REVISION 1 TO
THE DETAILED CONTROL ROOM DESIGN REVIEW
SUMMARY REPORT FOR SNUPPS

Wolf Creek Plant - Kansas Gas and Electric Co.

Callaway Plant - Union Electric Company

Revised June 1984

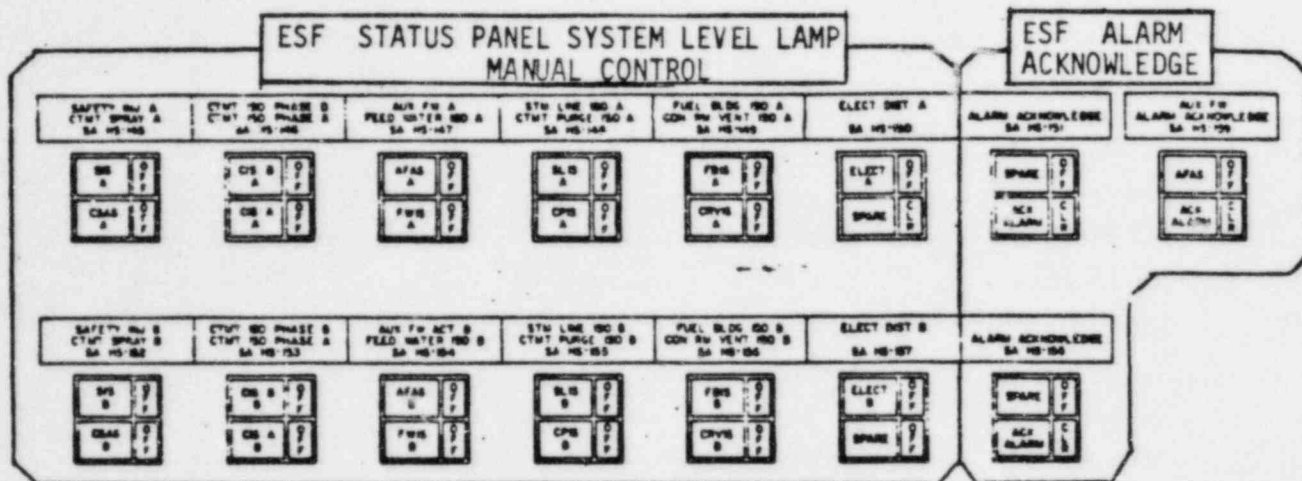
Finding 25 (2) The recorded data on the MAIN TURBINE VIBRATION AC and MAIN TURBINE TEMP + EXPAN impact recorders is printed on top of other data, making the information totally illegible. The graph lines on these recorders are a light blue color which provides poor legibility and contrast. In addition, the scaling on the graph paper does not correspond to the horizontal scale on the impact recorders. The data is recorded in the form of a number (1-16 or 1-20) of very small size that is difficult to read.

- Response The turbine recorders will print points that touch each other when all points have the same value. The operator uses the information on the recorder to determine points that vary from the norm. When a point varies from the remainder of the points, it will be obvious to the operator. The color of the graph lines and the scaling on the graph paper will be changed to improve legibility and correspond to the horizontal scale on the recorder. When a single point prints by itself on the paper, the number is legible and the print wheel also has a larger number on it to identify which point is printing. More detailed information can be obtained from the plant computer whenever the operator suspects a point is trending out of its normal range.

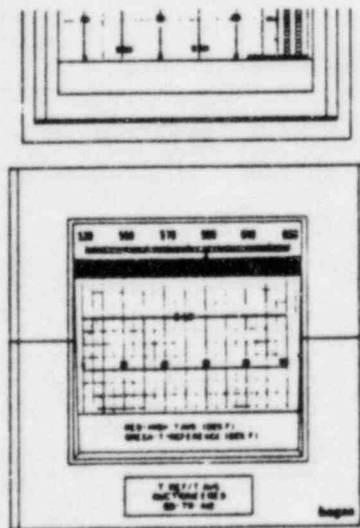
Finding 15 (2) The labels for some indicator lights on RL013, RL014, and RL018 are located below the lights. Labels are conventionally placed above their associated components elsewhere in the control room.

Response On panels RL013 and RL014, the nameplates for some indicator lights are located below the lights in order to provide needed information while maintaining the mimic to a reasonable size. On RL013, pump discharge valve position lights are located at the bottom of the panel and due to the specific arrangement, the identification of these lights is positive and unambiguous. On panel RL014, the 345kV circuit breaker controls consists of time-proven control switches and indicating lights. This arrangement provides the most compact arrangement possible for these devices considering back panel wiring. Operation of these controls is infrequent and does not require rapid component identification. In some cases control switches are only shown by the mimic, these nameplates are also located below the lights for consistency within the switchyard mimic.

Generally, all controls and indicators located on panels RL013 and RL014 are related to systems and equipment which are ancillary to the main unit operation and do not serve safety related systems. Operation of the controls on these panels is infrequent and requires unhurried responses. Additionally, these panels are located at the left extremity of the control board and will have minor effect to the operation of the other control panels.

PANEL RL003

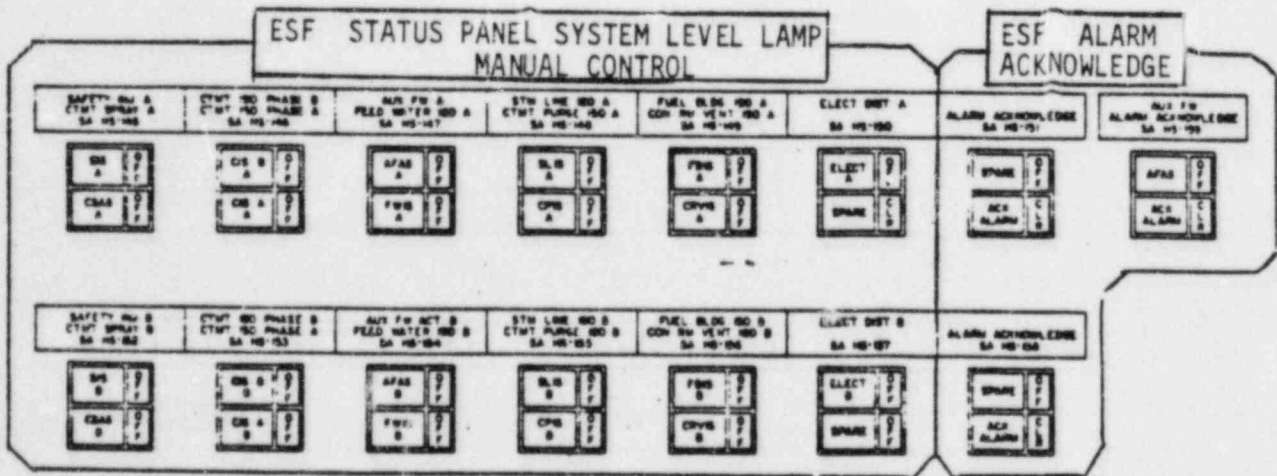
Finding 2 (3) The SAFEGUARD SYSTEMS STATUS SELECT switches on RLO03 are placed between the CRT and the keyboard, but they are not related to the process computer.

Response The Safeguards System Status Select switches will be labeled and demarcated. See 6.05 for a sketch.

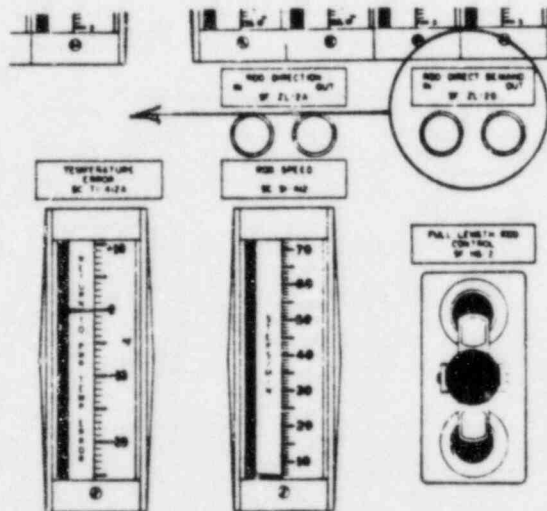
Finding 3 (1) There is inconsistent labeling between some trend recorders on RL018 and their associated controls on RL017. The numbers "1" and "2" are used for component identification within trains on the trend recorders, while the letters "A" and "B" are used for component identification within trains on the controls.

- Response The labels on recorders EJ-TR-613 and 612 will be changed to read "A" and "B" in lieu of "1" and "2".
- Finding 4 (2) The ROD INSERTION LIMIT and NEUTRON FLUX DETECTOR recorders on RLO22 that will be monitored during control manipulation on RLO03 are not located sufficiently close that an operator can read them clearly and without parallax from a normal operating position.

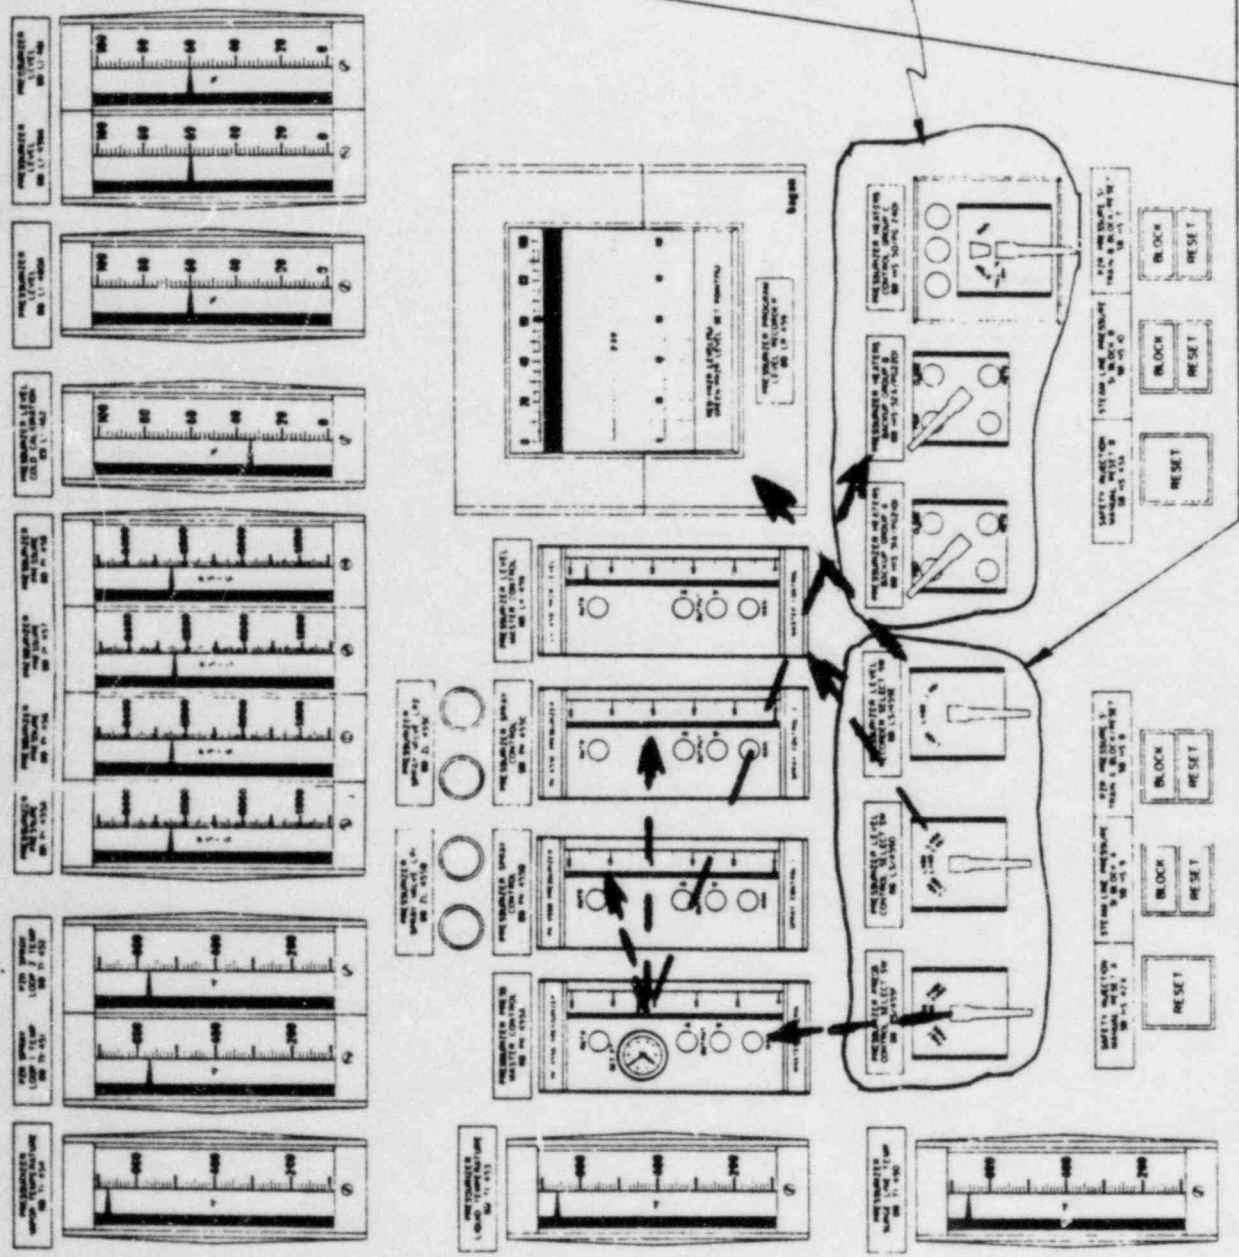
Finding 13 (2) The control groups in the CVCS mimic are in reversed orientation from their associated displays. The LET-DOWN HX OUTLET control is located on the left half of RLO01. The LETDOWN HX OUTLET display is located on the right half of RLO02. The BORIC ACID TO VCT controls are located on the right half of RLO01. The BORIC ACID TO VCT display is located on the left half of RLO02.

Response The Letdown HX Outlet display is located towards the center of RLO02. Pressurizer controls and displays are on the right half of RLO02. The existing arrangement places the key displays and controls concerning pressurizer level, and pressure immediately adjacent to the reactivity controls and indications where one person can readily monitor the major reactor system parameters. The controls and indication on RLO02 for boric acid constitute a stand alone control station for boration and dilution. The controls on RLO01 would be used manually only if those on RLO02 malfunction. Automatic controls are located on RLO02. The operator has the option of selecting either "manual" or "automatic" functions. Boration and dilution are not fast response actions.

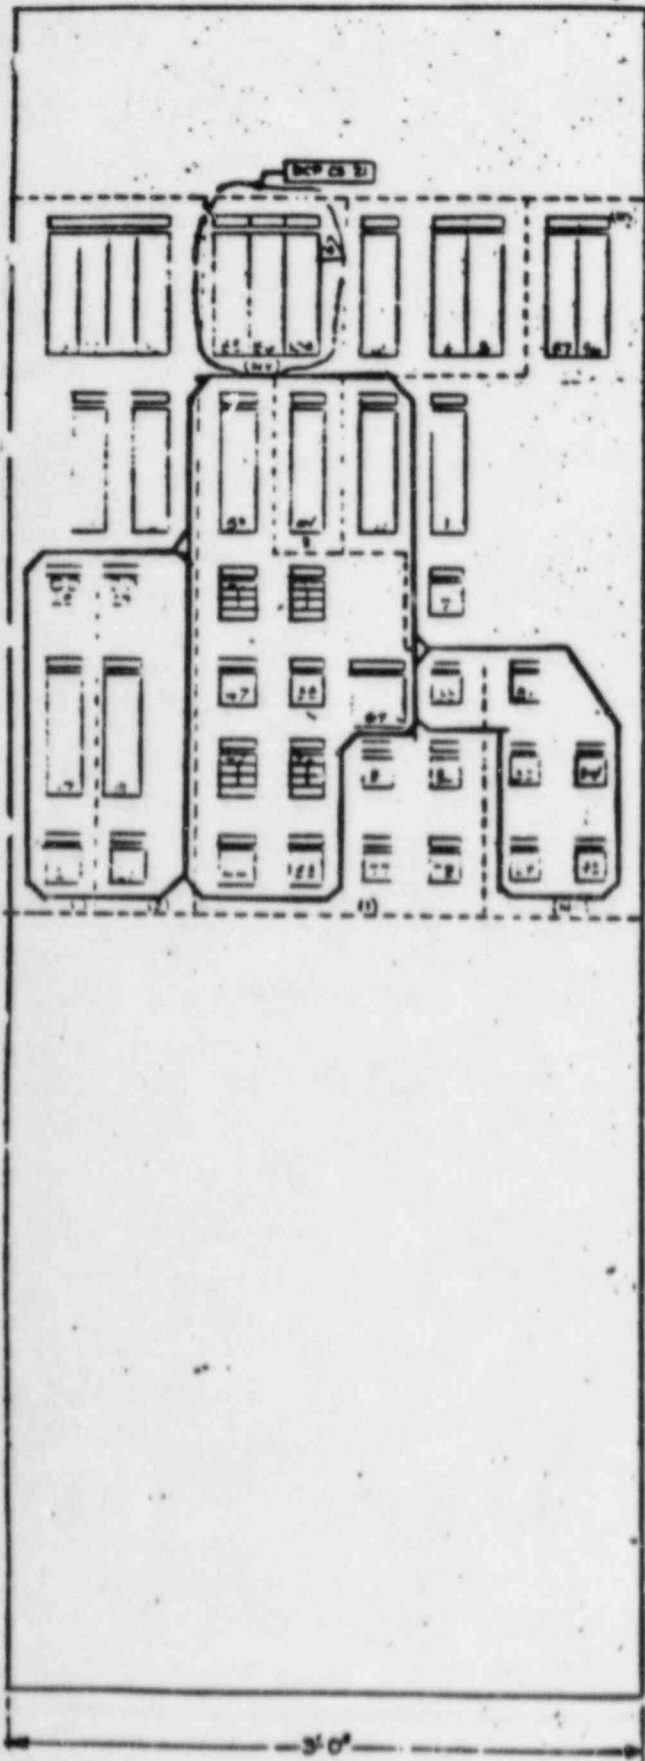
Finding 3 On panel RP118B, the indicators for M.D. auxiliary feedwater
(2) pump suction and discharge pressures are located one above the other, whereas the indicators for TD auxiliary feedwater pump suction and discharge pressures are located side by side.

Response Since these indicators are used as status monitors and not for control purposes, and the indicators can be located quickly, it is acceptable to leave the indicators in their present arrangement.
